AMENDMENT OF SOLICITATION/MODIFICATION OF CONTRACT

SUBJECT: LITTLE CALUMET RIVER, INDIANA, LOCAL FLOOD PROTECTION, STAGE 5 PHASE 2, MUNSTER, HAMMOND, AND HIGHLAND, INDIANA

1. By way of this Amendment 0001, the Bid Opening Date is extended from 6 September 2007 to 12 September 2007. The Bid Opening time remains the same at 2:00 p.m. Chicago Local Time.

SHEET REFERENCE NUMBER:
C-11
SHEET 15 OF 138

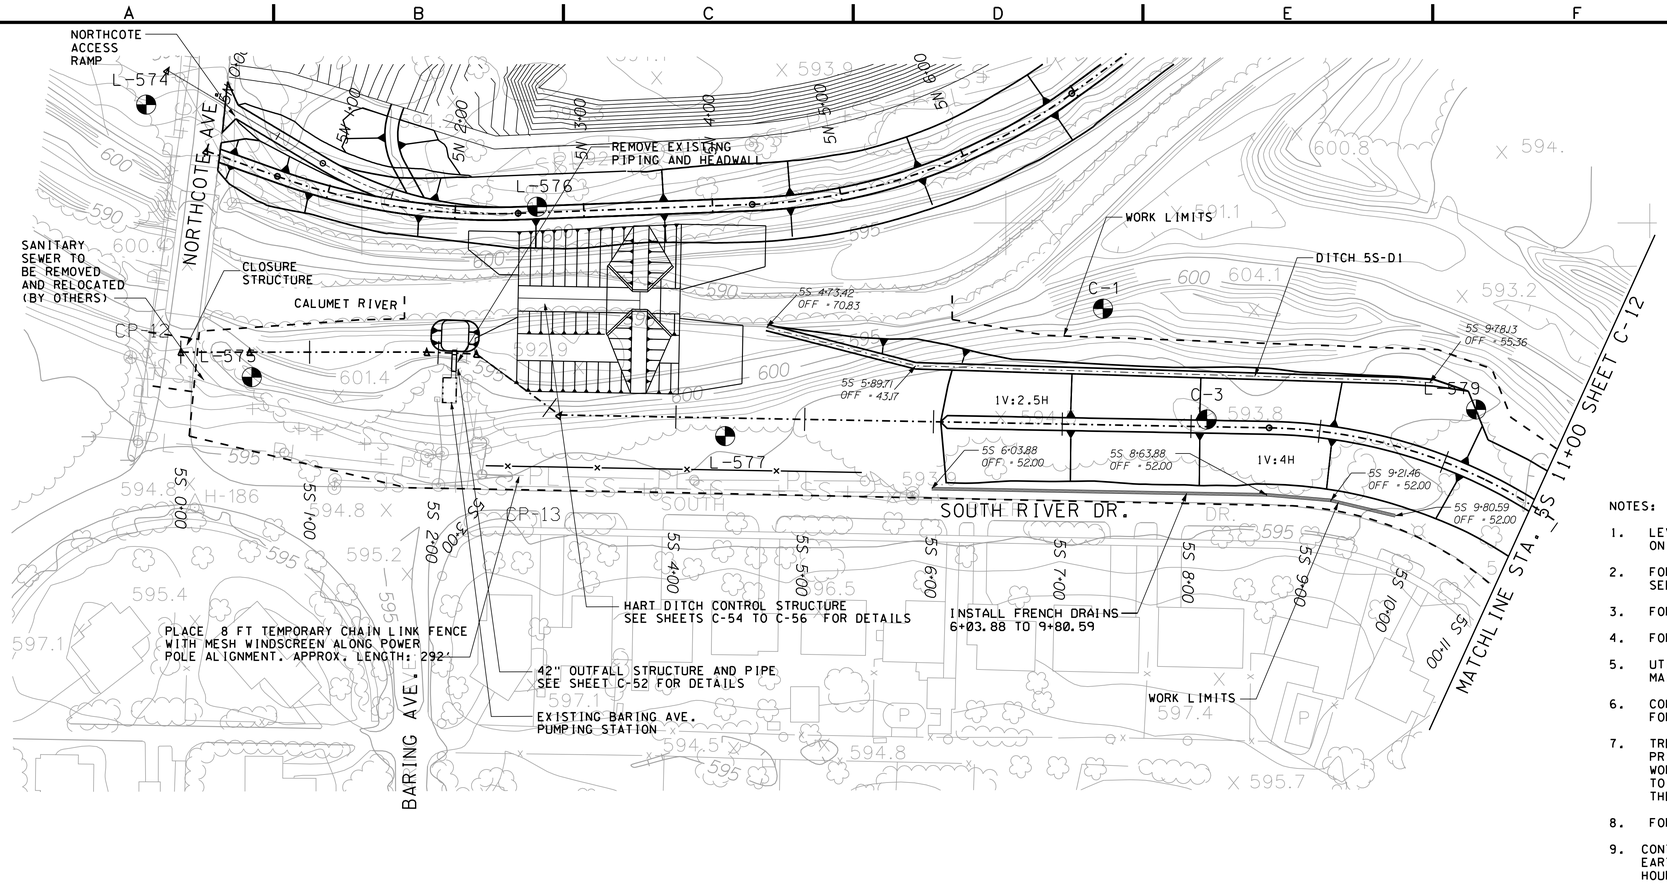
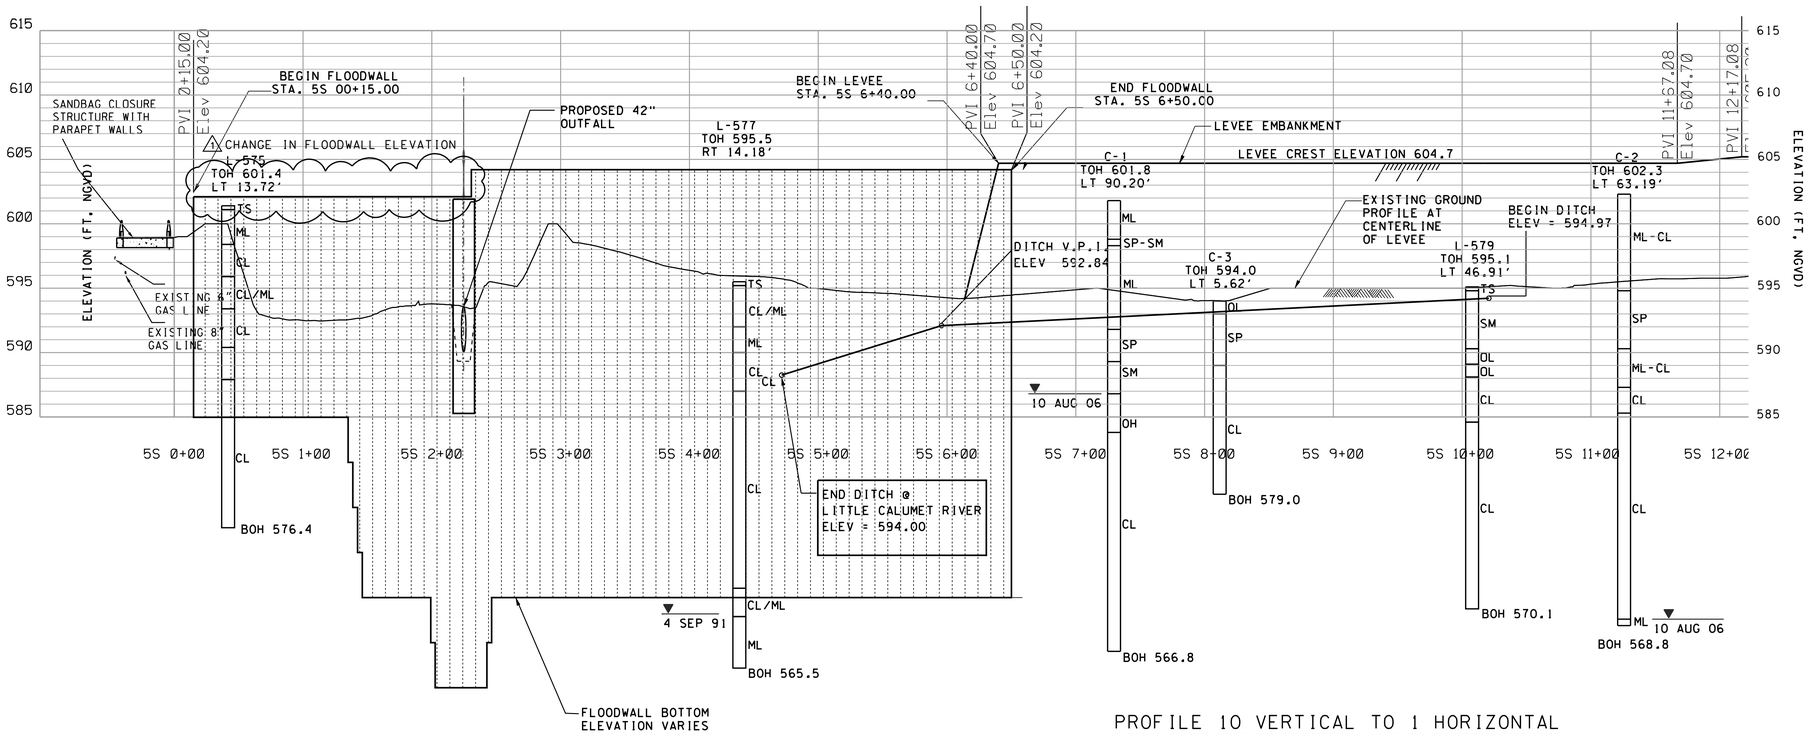
Question 13. Sheet C-11 a ditch, %S-D1 is noted on the plan from 4+73.42 to 9+73.13 yet none is shown on the cross sections on sheet C-26, further investigation indicates that none of the ditches listed on the plan sheets are indicated in the cross sections – please comment. Also the elevation of the bottom & top of the sheet pile wall shown on this sheet, (585 & 604) does not agree with the elevation shown on sheet S-01 (568 & 602.1) – are the elevations shown on the S sheets correct and can these be used over the C sheets? – please comment.

Question 15. Sheet C-26 at cross sections 5S 7+00, & 9+00 wick drains are indicated but there is no pay item for wick drains in that area nor are there any drains indicated on sheet C-43 – please comment.

Top of wall shown in the profile on the Revised Drawing Sheet C-11, which was amended to match structural sheets - the revised Drawing Sheet is attached hereto. Structural sheets should be used for all elevations.

Response 15. It was incorrectly labeled; it should be French drain as indicated on the Revised and attached Drawing Sheet C-11, which has the location and typical section detailed.

SHEET REFERENCE NUMBER:
C-46
SHEET 50 OF 138

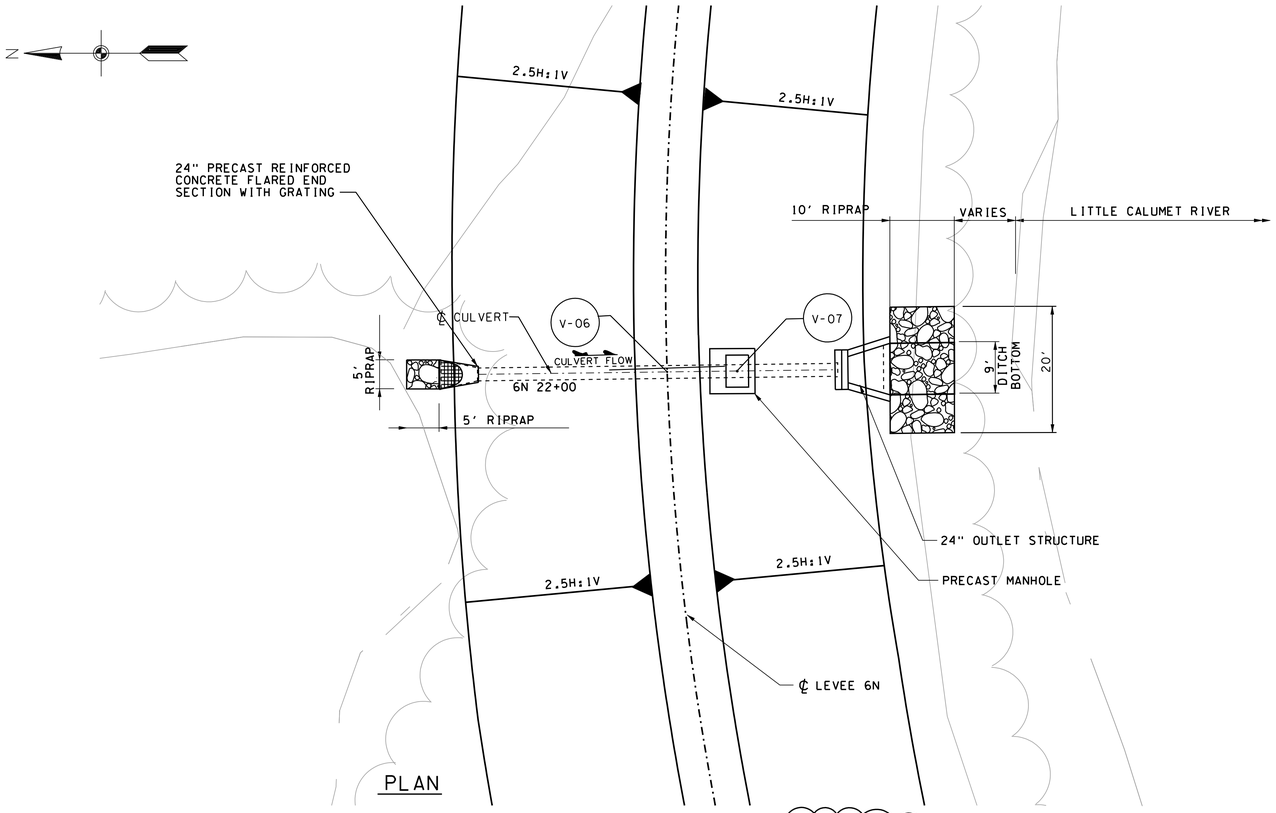
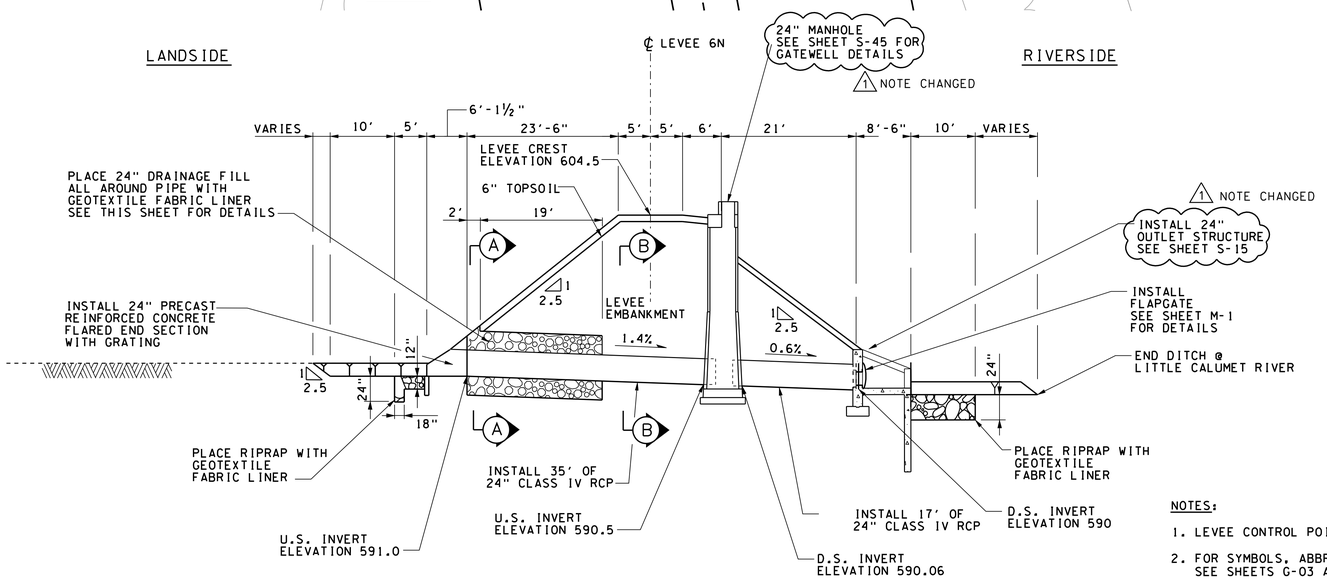
Question 16. Sheet C-46 in the plan view for Culvert 6-5C indicates a precast manhole but the cross section view indicates a gate well – please comment.

Response 16. It was incorrectly labeled in the cross section. It is a 24" manhole, which has been corrected by way of the Revised Drawing Sheet C-46, which is attached hereto.

SHEET REFERENCE NUMBER:
S-04
SHEET 80 OF 138

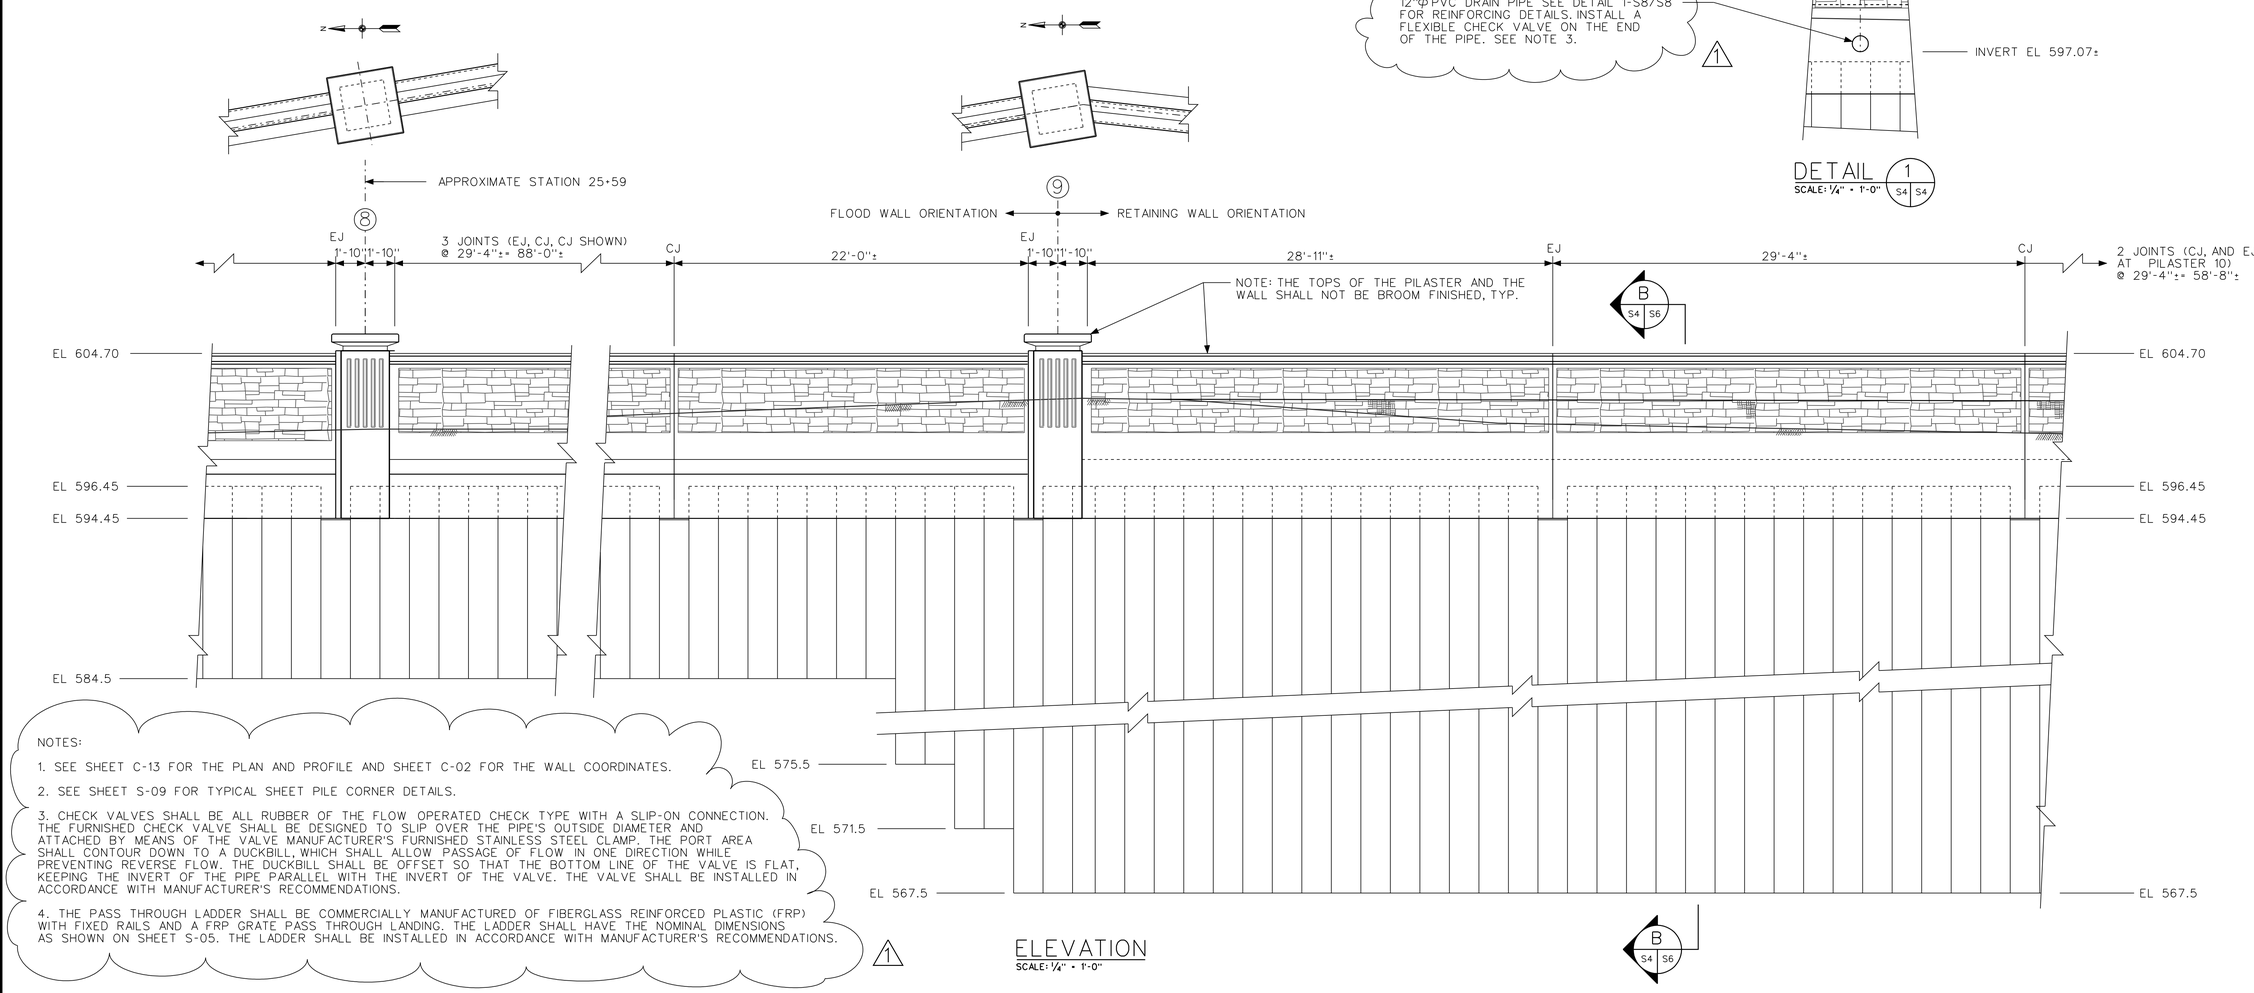
Question 18. Sheet S-04 at location F4 there is a note to install a flexible check valve at the end of a pipe. What pay item should include this item and what are the specifications for this valve?

Question 19. Sheet S-05 at location E6 & H6 a ladder is shown, what pay item is this included in and there are no details of this ladder.

Response 18. The valve shall be included in the pay item for the Hart Ditch I-Wall. The following Specification Note has been added to the Revised and attached Drawing Sheet S-04 as follows:

Response 19. The valve shall be included in the pay item for the Hart Ditch I-Wall. Nominal dimensions added to Sheet S-05. Also, the following Specification Note has been added to the Revised and attached Drawing Sheet S-04 as follows:

> *4. THE PASS THROUGH LADDER SHALL BE COMMERCIALLY MANUFACTURED OF FIBERGLASS REINFORCED PLASTIC (FRP) WITH FIXED RAILS AND A FRP GRATE PASS THROUGH LANDING. THE LADDER SHALL HAVE THE NOMINAL DIMENSIONS AS SHOWN ON SHEET S-05. THE LADDER SHALL BE INSTALLED IN ACCORDANCE WITH MANUFACTURER'S RECOMMENDATIONS.*

SHEET REFERENCE NUMBER:
S-12
SHEET 88 OF 138

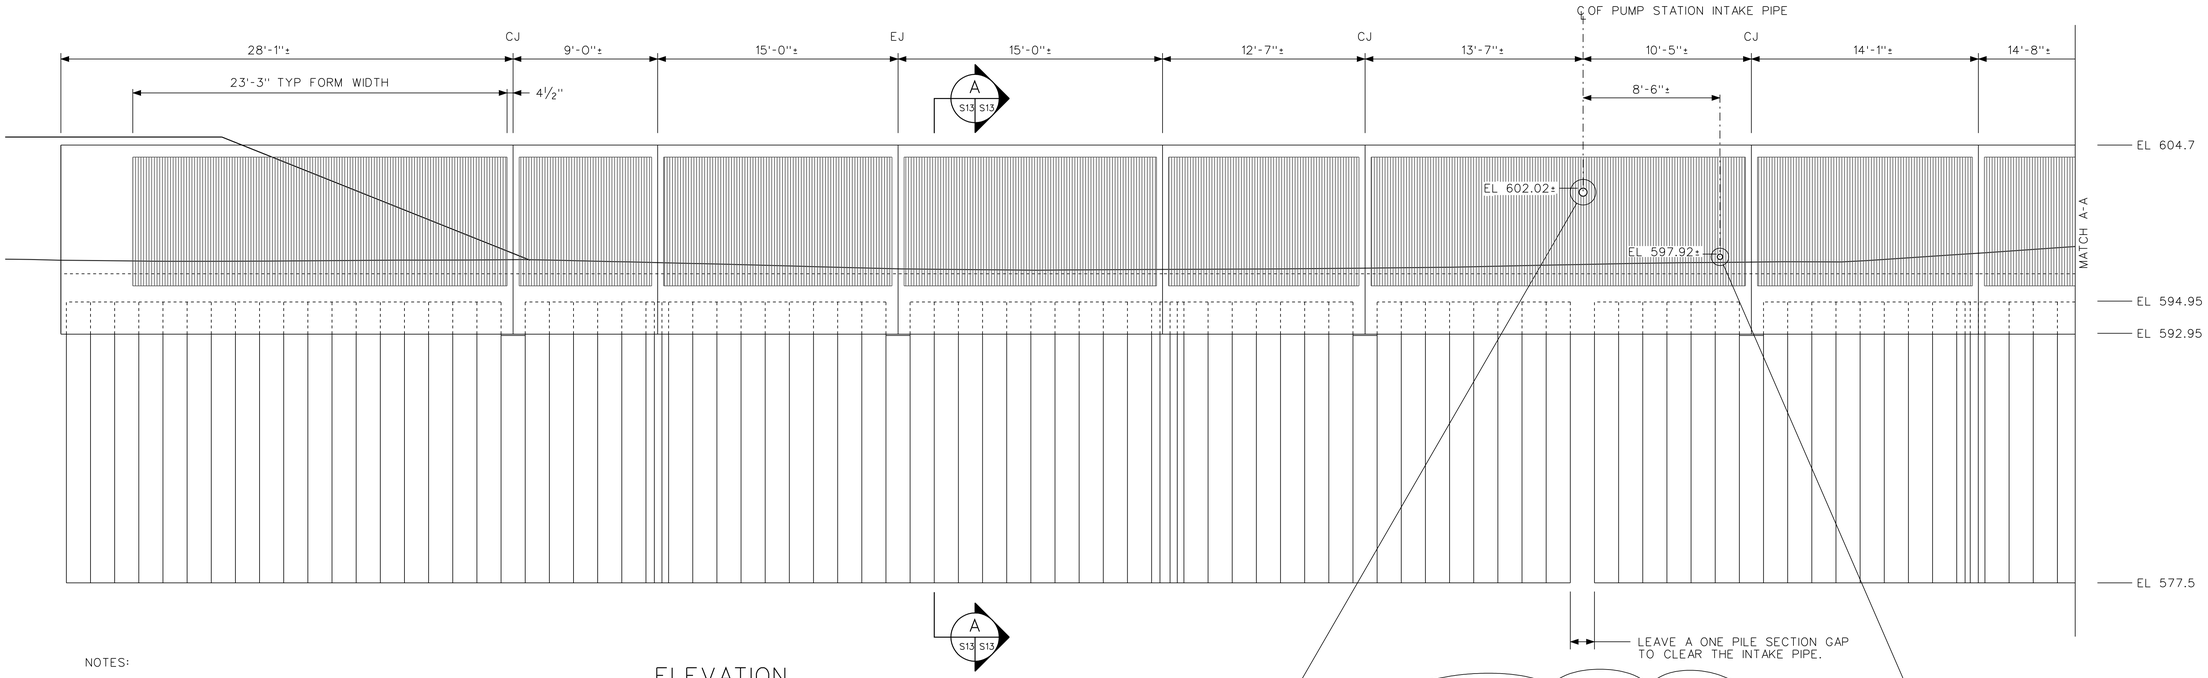
Question 21. Sheet S-12 Section C/S2/S12 the dimension on the right (13'-5") agrees with the elevations shown but the dimensions on the left add up to 13'-9", please comment.

on the right. The dimensions have been corrected by way of the Revised and attached Drawing Sheet S-12.
